# SHOPS AT MCLAUGHLIN II

SITE PLAN

## Add PCD File No. PPR-17-055

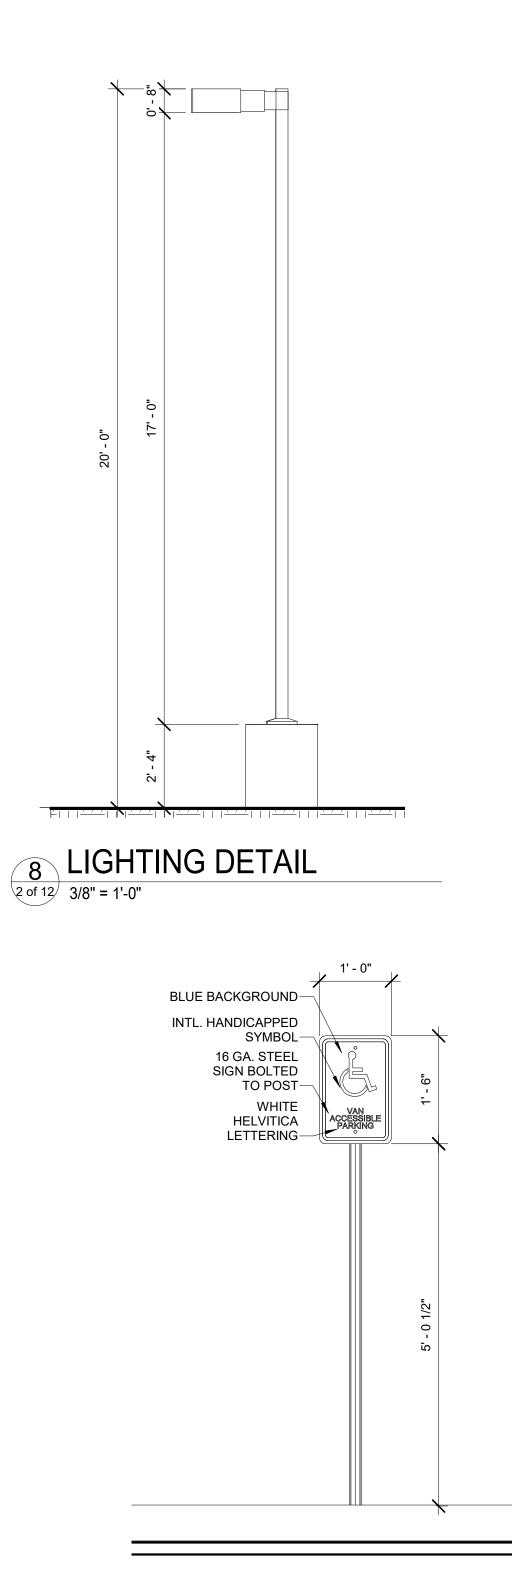
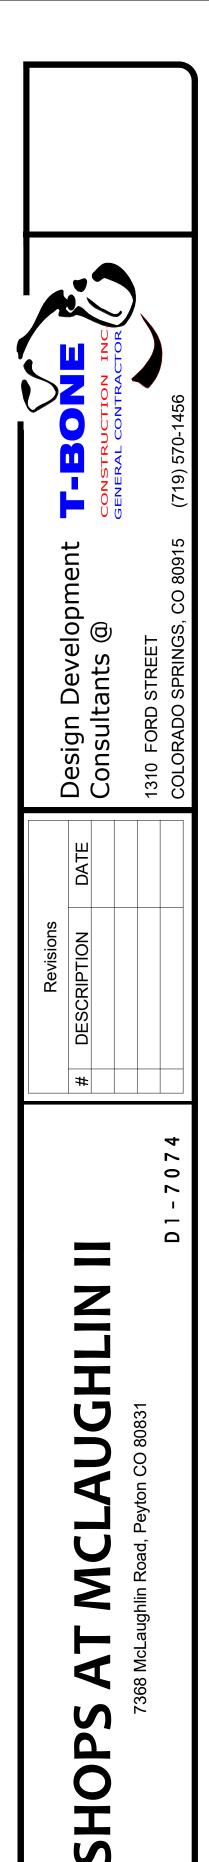
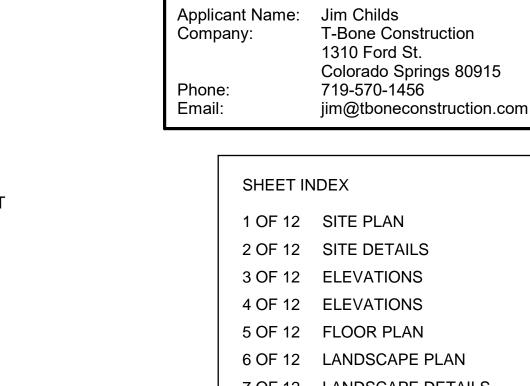
Each site development plan or non-residential site plan submitted to El Paso County shall clearly illustrate and identify the provision of ADA accessible exterior routes in accordance with the applicable ADA design standards and guidelines as published by the United States Department of Justice

feet. Based on suggested uses, highest standard must be met Required parking is 24 parking spaces. Letter of Intent should address any modification request Letter of Intent should also indicate there will be no restaurants at location. as restaurants are 1

And an and a second sec	Subject: Callout Page Label: 1 Lock: Locked Status: Checkmark: Unchecked Author: dsdsevigny Date: 1/11/2018 2:42:08 PM Color:	dead space, suggested to move dumpster location here and move loading area to allow for more parking, also will allow trash truck to maneuver without blocking parking and damaging parking lot

Subject: Callout Where is sidewalk and curb ramps? Also Sidewalk Page Label: 1 needs to be continued to property line. Lock: Locked Status: Checkmark: Unchecked Author: dsdsevigny Date: 1/11/2018 2:42:09 PM Color: ..... Subject: Callout Table 6.4 of the LDC requires a parking space with Page Label: 1 0 degrees to have a minimal depth of 22 feet Lock: Locked Status: Checkmark: Unchecked Author: dsdsevigny Date: 1/11/2018 2:42:05 PM Color: ..... Subject: Callout Not indicated on site plan Page Label: 1 Lock: Locked Status: Checkmark: Unchecked Author: dsdsevigny Date: 1/11/2018 2:42:10 PM Color: Subject: Callout Not indicated on plan at perimeter Page Label: 1 Lock: Locked Status: Checkmark: Unchecked Author: dsdsevigny Date: 1/11/2018 2:42:10 PM Color: Subject: Callout General Retail is 1 for 250 square feet. Based on Page Label: 1 suggested uses, highest standard must be met. Lock: Locked Required parking is 24 parking spaces. Letter of Status: Intent should address any modification request. Checkmark: Unchecked Letter of Intent should also indicate there will be no Author: dsdsevigny restaurants at location, as restaurants are 1 Date: 1/11/2018 2:42:03 PM parking per 100 square feet. Color: ..... Subject: Callout Inadequate design, a curb cut must be provided to Page Label: 1 allow maneuvers to back up, see Starbucks at Lock: Locked Academy Gateway for approved plans.

DETAILS

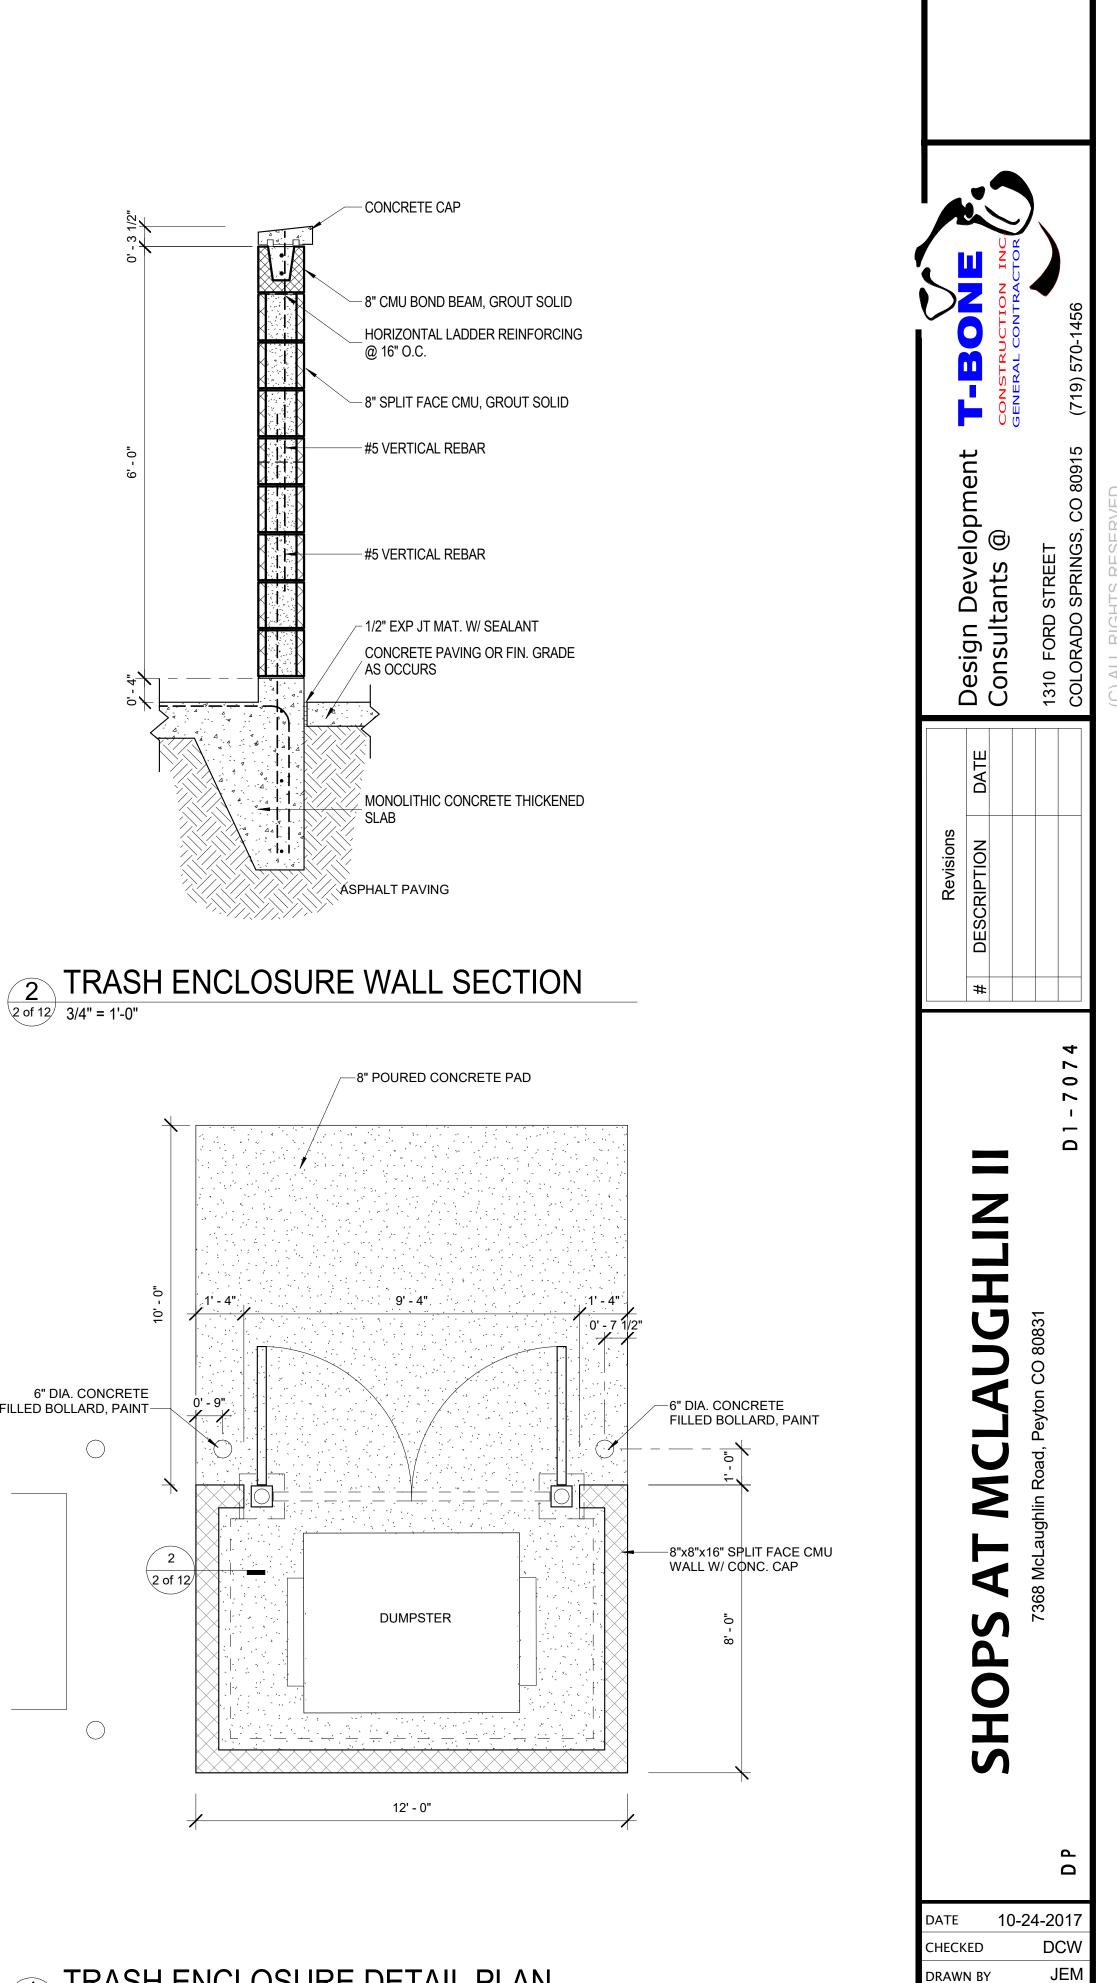
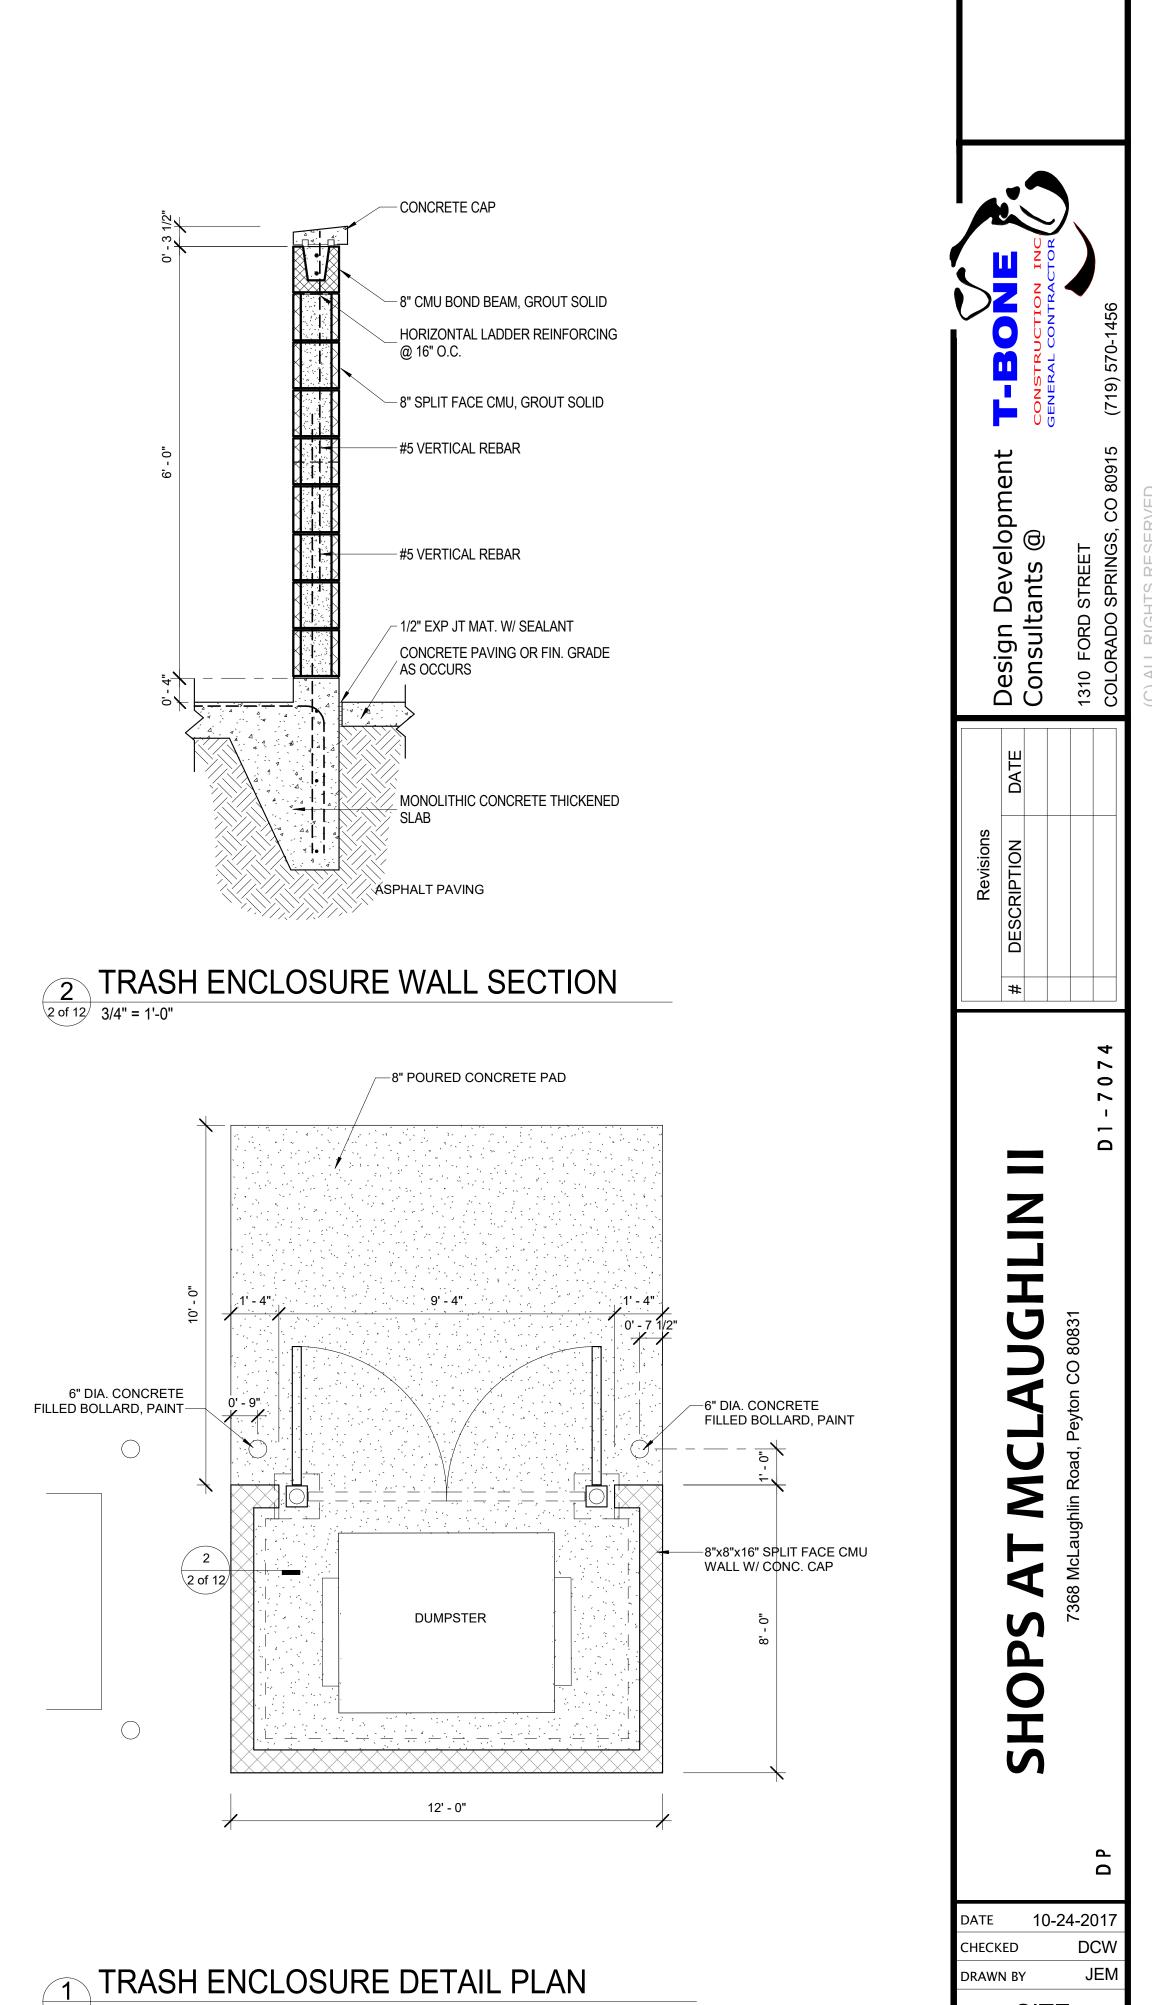
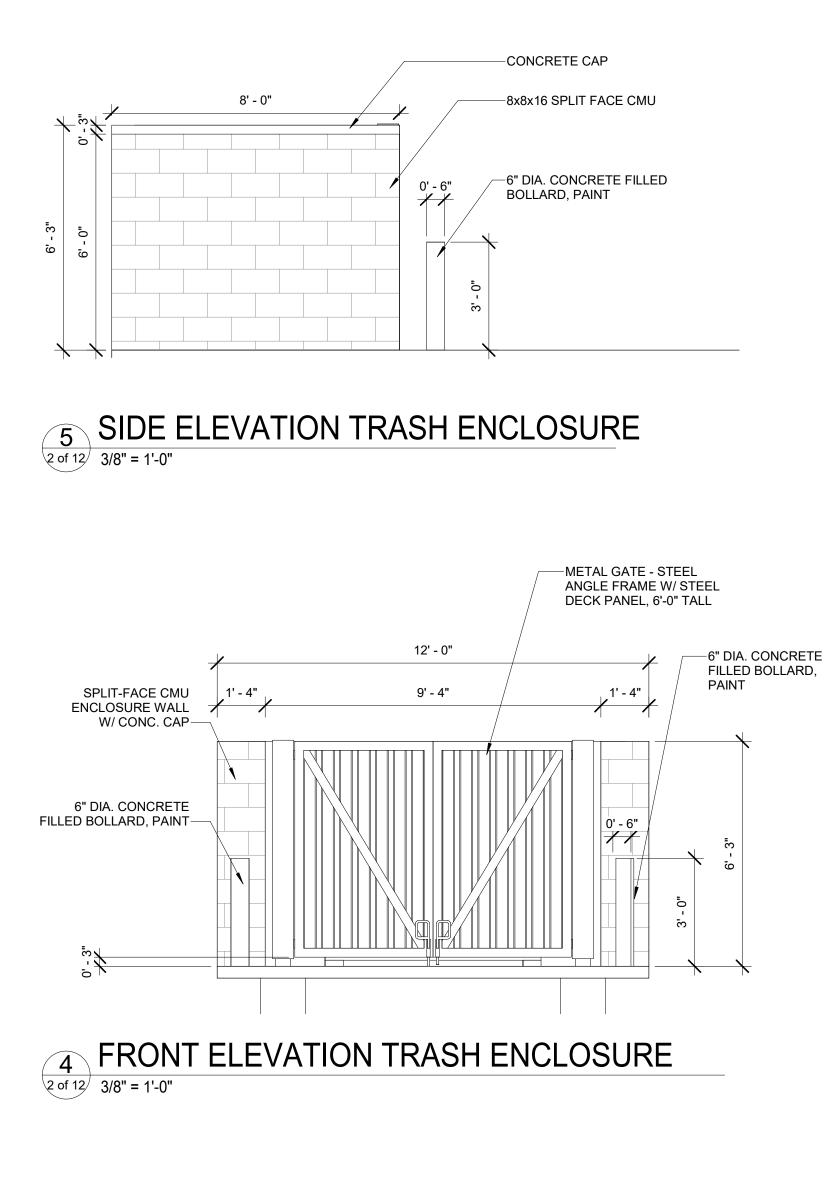
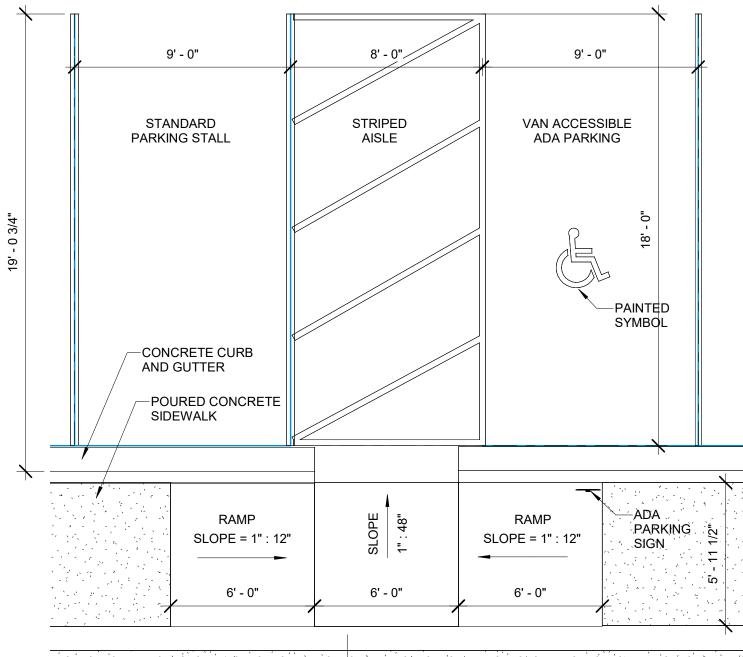
ADA curb ramps also need to be included on detail page
